Exhibit B

License Amendment Request Dated March 31, 1989

Docket No. 50-263 License No. DPR-22

Exhibit B consists of revised pages for the Monticello Nuclear Generating Plant Technical Specifications annotated to show the proposed wording changes:

Figure 3.6.3 Minimum Temperature vs. Pressure for Mechanical Heatup or Cooldown Without the Core Critical

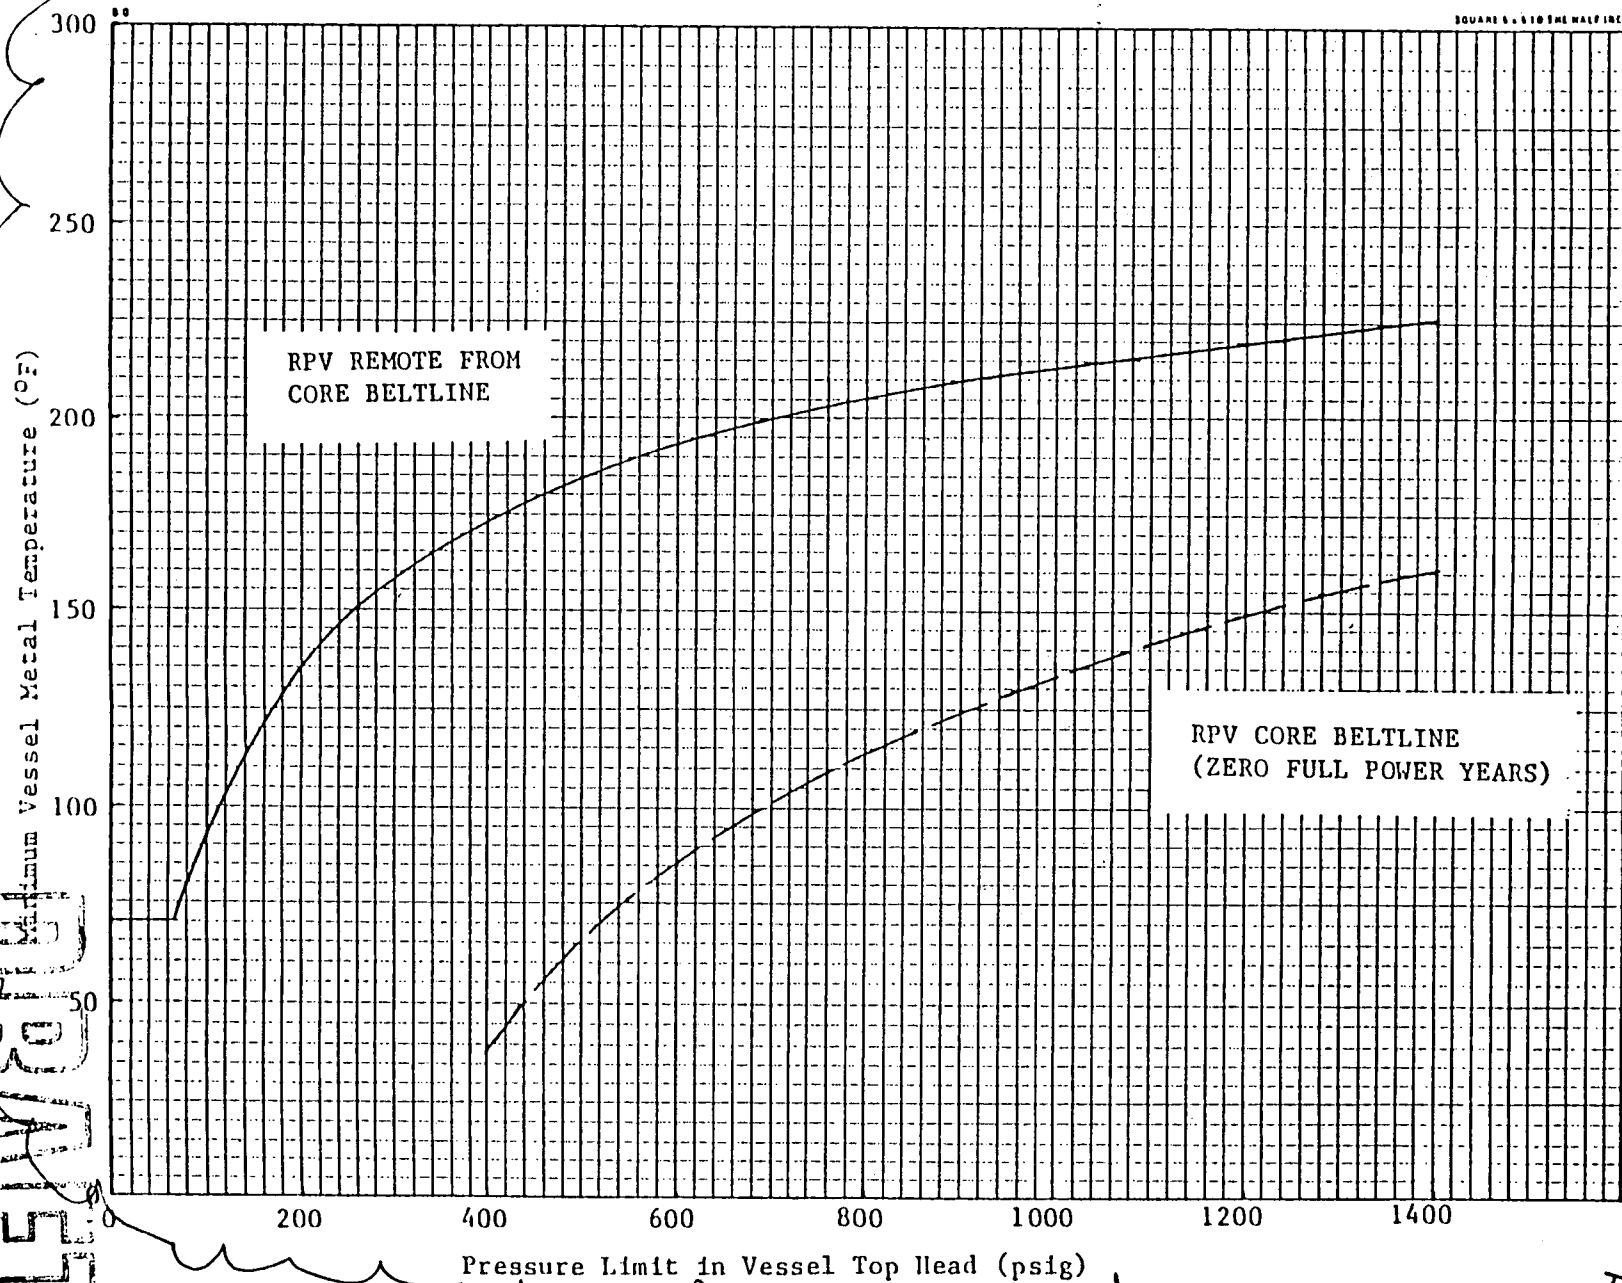
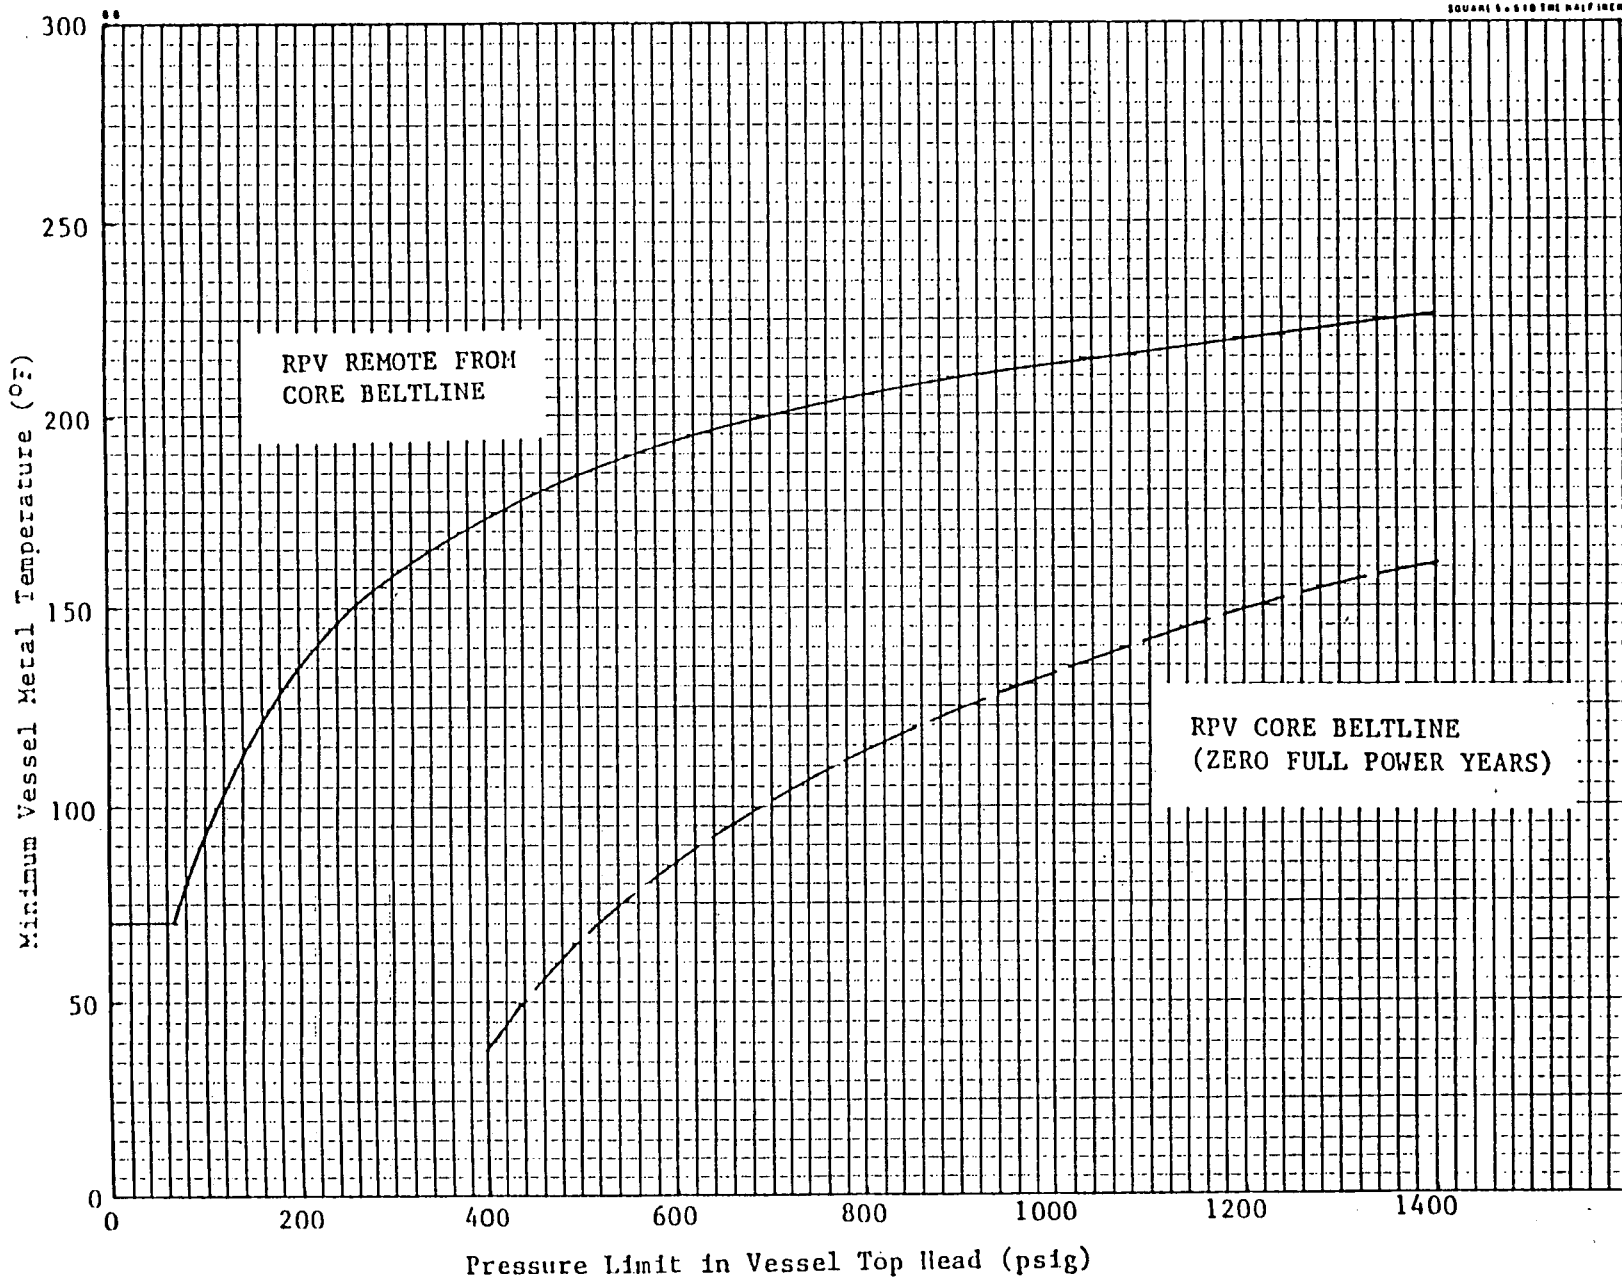
2. During heatup by non-nuclear means (except with the reactor vessel vented), cooldown following nuclear shutdown, or low level physics tests the reactor vessel shell and fluid temperatures specified in 4.6.A shall be at or above the higher of the temperatures of Figure 3.6.3 where the dashed curve, "RPV Core Beltline," is increased by the expected shift in RT_{NDT} from Figure 3.6.1.

Figure 3.6.4 Minimum Temperature vs. Pressure for Core Operation

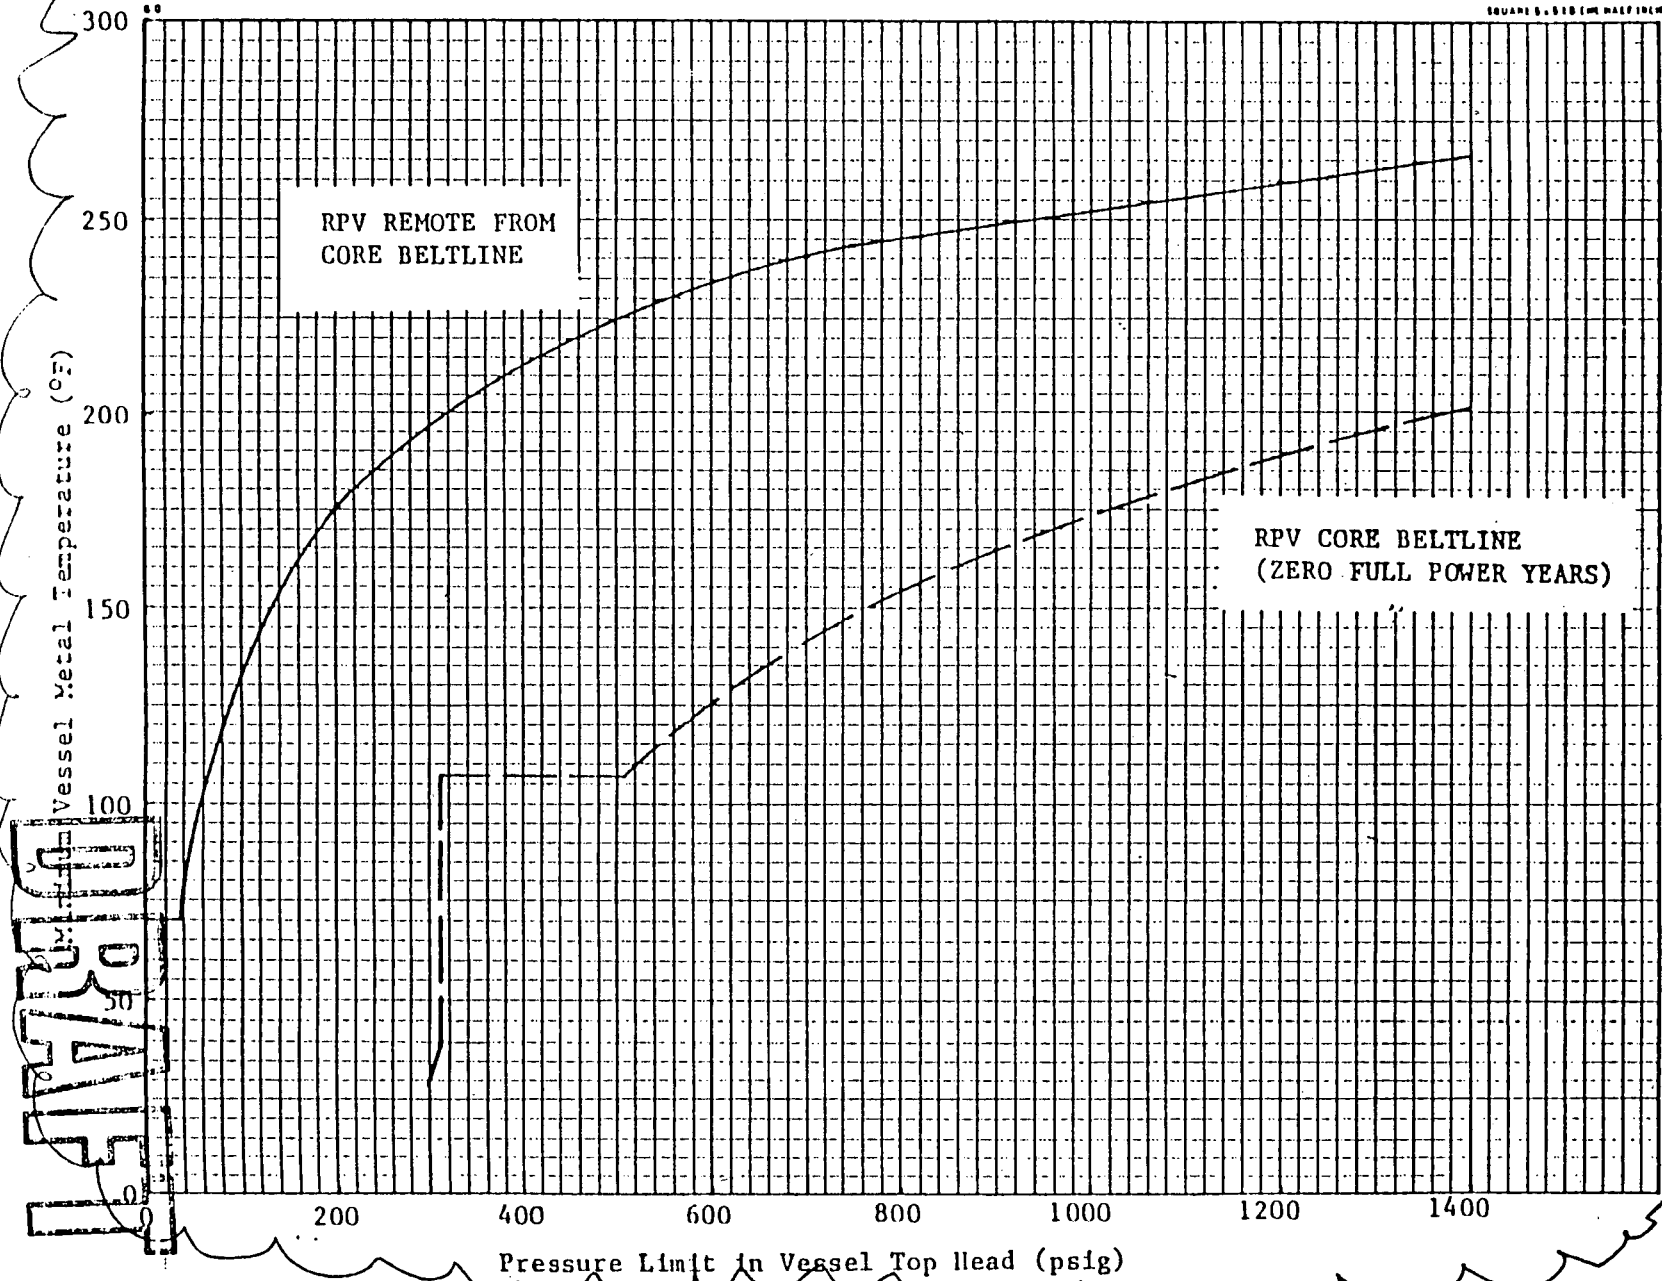
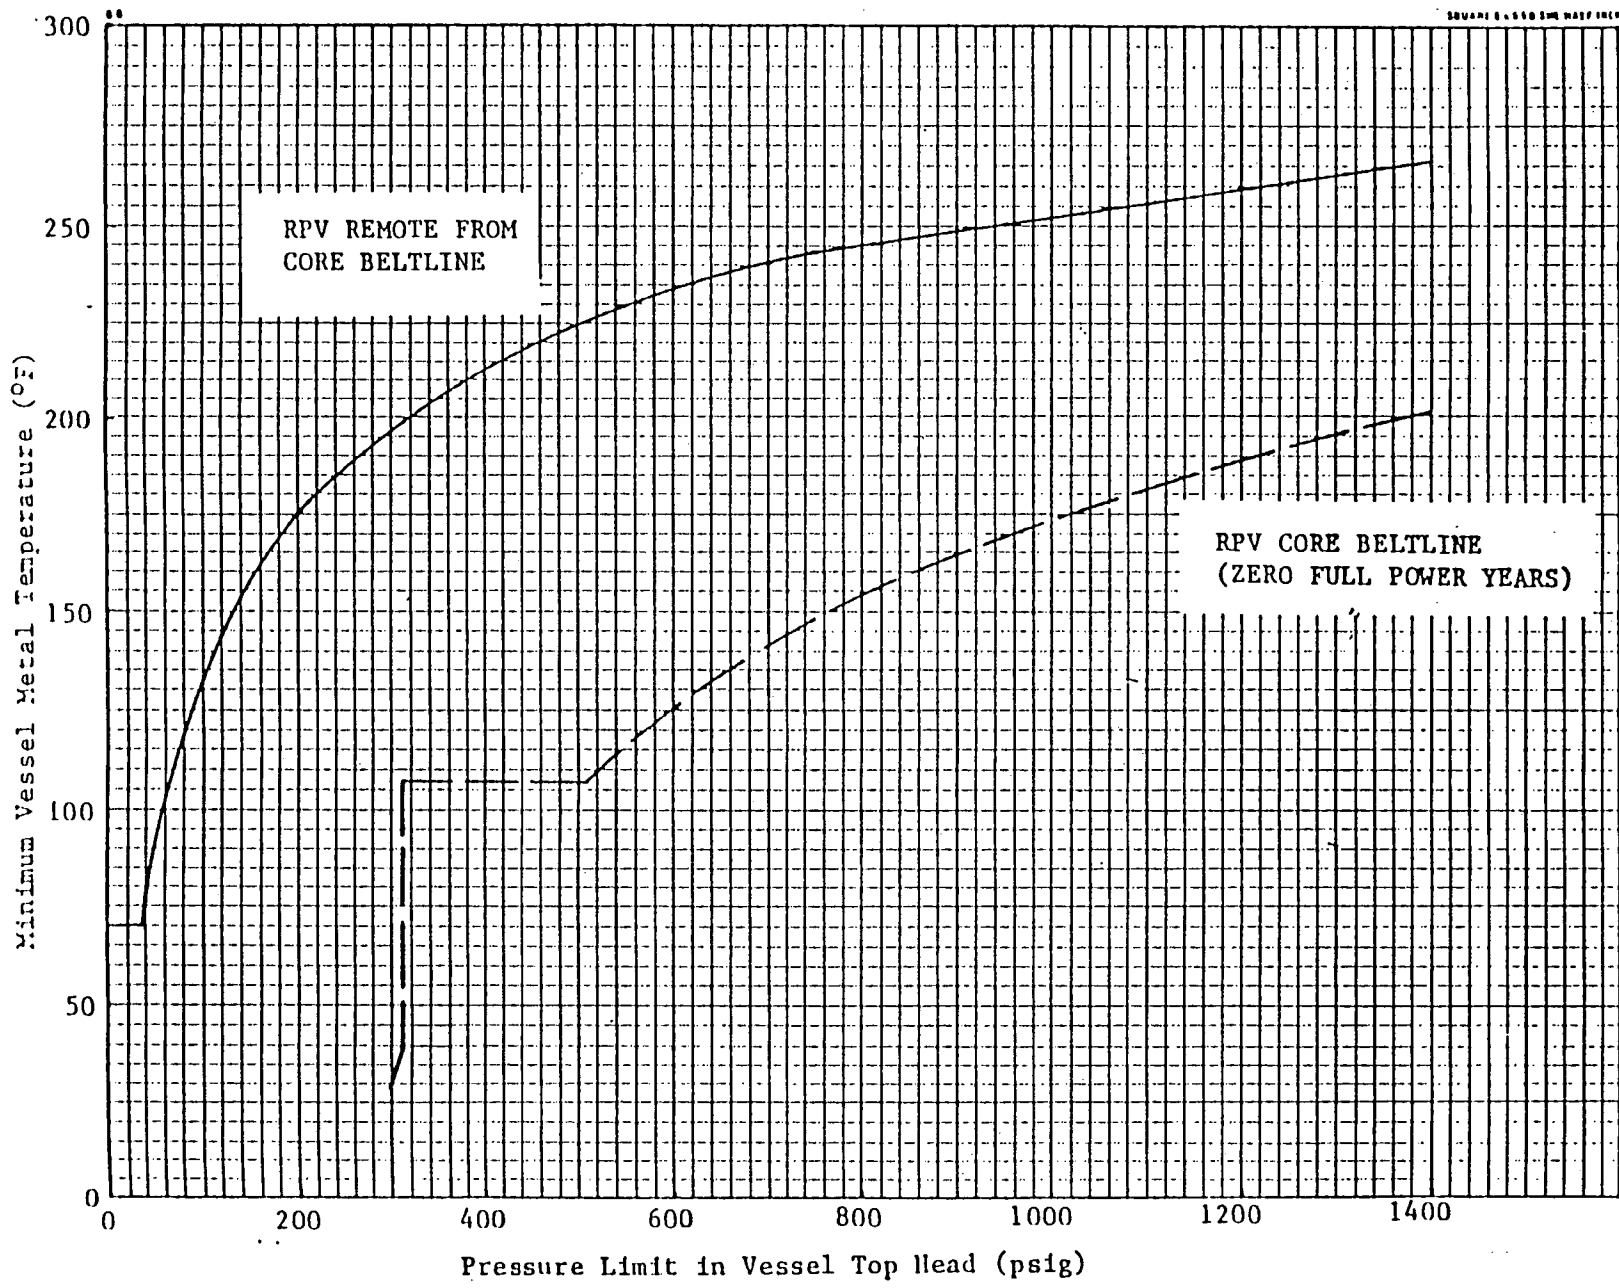
3. During all operation with a critical reactor, other than for low level physics tests or at times when the reactor vessel is vented, the reactor vessel shell and fluid temperatures specified in 4.6.A shall be at or above the higher of the temperatures of Figure 3.6.4 where the dashed curve, "RPV Core Beltline," is increased by the expected shift in RT_{NDT} from Figure 3.6.1.
